**OFFICIAL COORDINATION REQUEST FOR
NON-ROUTINE OPERATIONS AND MAINTENANCE**

COORDINATION TITLE- 15BON87PH1 main unit breaker replacement.

PROJECT- Bonneville Lock and Dam

Figure 2. BON 6 year average, 2009-2015, Subyearling Chinook

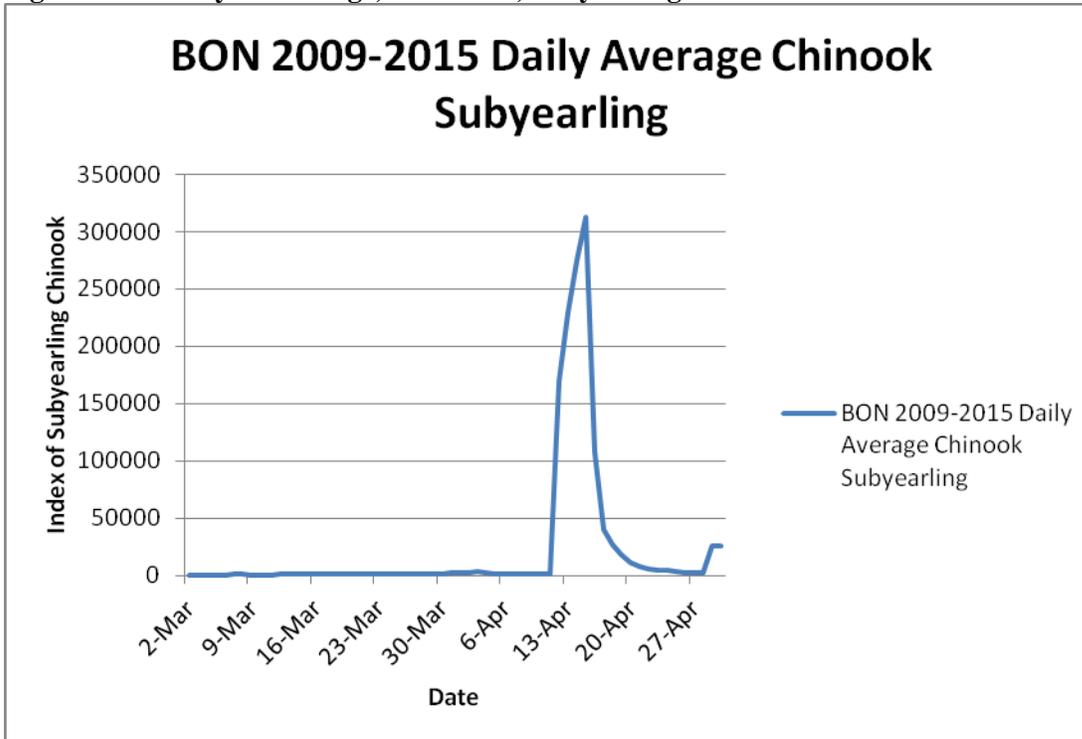
I can't say I'm too crazy about this one. As the graph indicates there can be a lot of Chinook passing the project in mid-April. We aren't expecting a great run this next year but that just makes every one we get back that much more valuable. I can't predict sea lion abundance next year but if it is anything like last year, we should be concerned. Changing unit priority can cause adult delay, particularly since we closed the mid-powerhouse floating orifices years ago. It is likely that only WG-64 would be operating on that side of the river. Anything more than a couple of units running would be a concern. What is the likelihood of this happening given the operation record at the project? What is the reason for delay of the breaker work? Is there any chance this could be resolved? Can the work be compressed to be completed by mid-April? Right now I would say that this work should be completed and the priority units returned to service no later than April 15. In any case, we should also reconsider the interim unit priority in FPOM. I agree there should be minimal impact to juvenile passage. Thanks, Gary

Here's what I can tell you. I think the possibility of needing to have more than a few units running at PH1 that time of year is very real. Do we have evidence that not having the end unit running causes significant delay for fish finding the ladders? We could re-prioritize to minimize delay but obviously 8 would be as close as we could get at that end. The delay is due to the contractor not supplying an acceptable engineered plan to HDC to do the work. It cannot be resolved as the delay has already occurred. At this point, the breakers are set to be here January 4th. I do think compressing the work to be finished by mid-April is a very real possibility. Having the fish managers demand this will be necessary to insure it is understood.

Karrie, It looks like more than the data were updated in this version since the end date for the work is now April 15 as we discussed in FPOM. Given this, I can agree with the schedule. However, there may still be adult passage impacts and therefore, I believe it is important to discuss PH1 unit priority further in FPOM. I suggest developing a couple of priorities based on what we know from the old modeling work and from prototype tailrace observations and then (lacking a model) go to the project and test them. I think the default FPP priority without units 9 and 10 may cause an eddy in the area of the north powerhouse entrances that might impact adult attraction. We should confirm this. If we think only a small number of PH1 units might operate, we might consider focusing unit flow on the south side where we have good ITS entrance capacity, ITS exit egress benefits and, hopefully, no unit outages. Thanks for the update. Gary

Figure 5. BON outflow (kcfs)

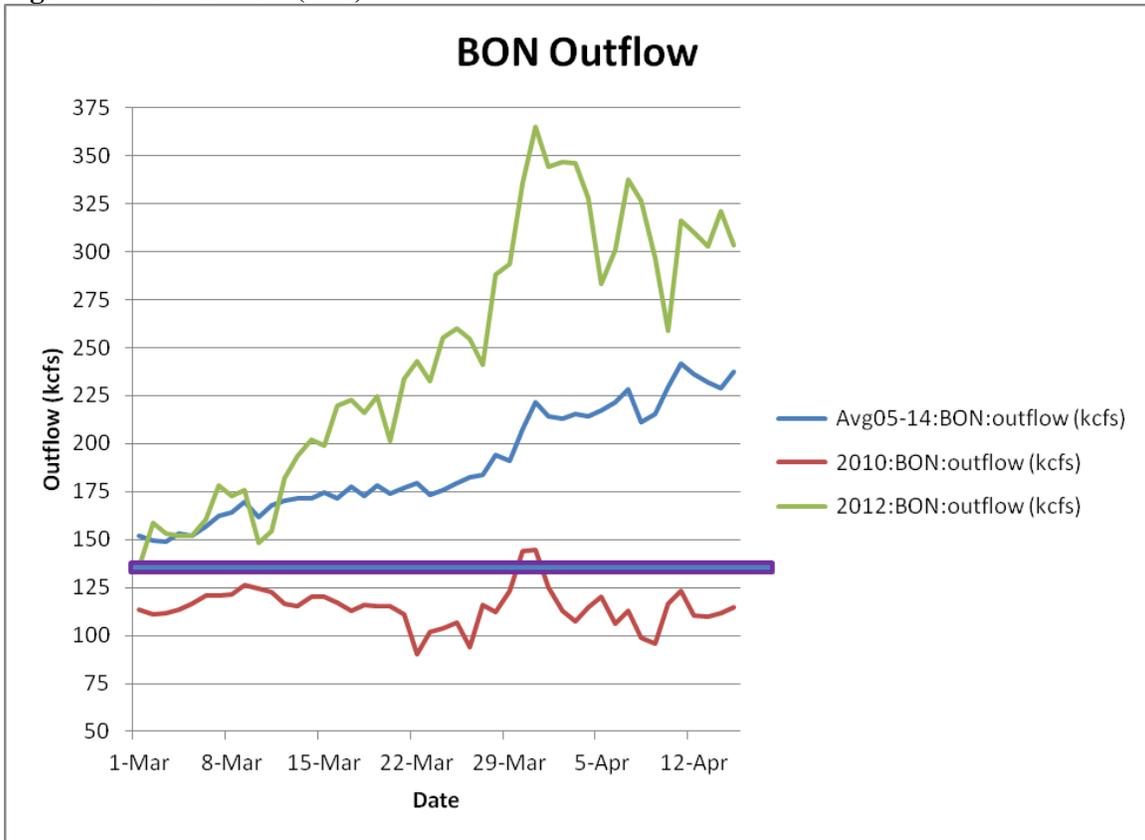
Figure 5 includes the 10 year average outflow, blue line; a high flow year in 2012, green line; and a low flow year in 2010, red line. The purple bar represents the maximum outflow for PH2 and all miscellaneous flow, about 136 kcfs, (Table 1) except for the B2 Corner Collector. In 2010, flow peaked at about 145 kcfs on 29 March, so about 5.5 kcfs needed to go through PH1, resulting in the need for a PH1 unit to operate. In 2012, flow peaked at about 360 kcfs, so about 210 kcfs needed to go through PH1 and spill, due to other miscellaneous flow (Table 1).
